PLANNING CONSULTATION RESPONSE

Application No	2026/0232
Proposal	Erection of 119 dwellings, open space and associated infrastructure
Address	Land to the south of Bloomhouse Lane, East of Woolley Colliery Road, Darton Barnsley
Date of Consultation Reply	21/05/26
Consultee	Highways DC

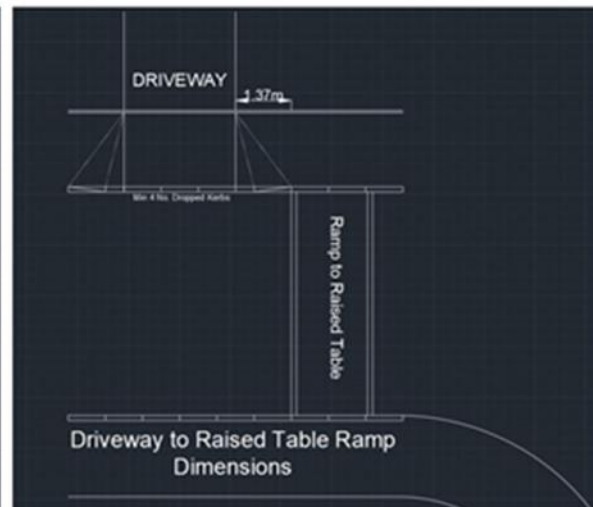
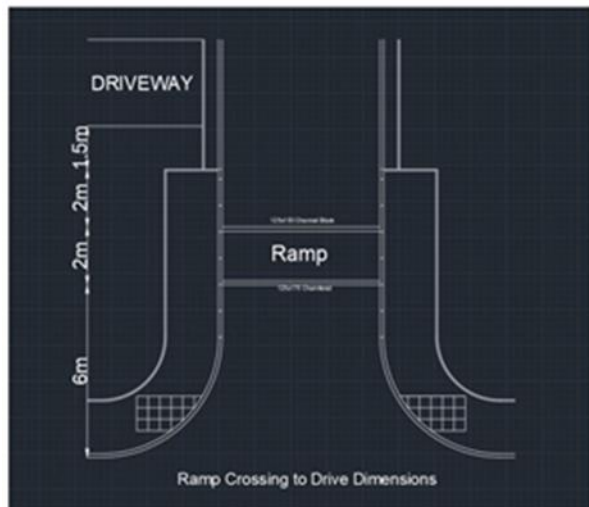
- Any proposed ramps (such as the one adjacent to plot 72 and 73) should be designed to the below dimensions maintaining the advised gap between driveway and ramp:
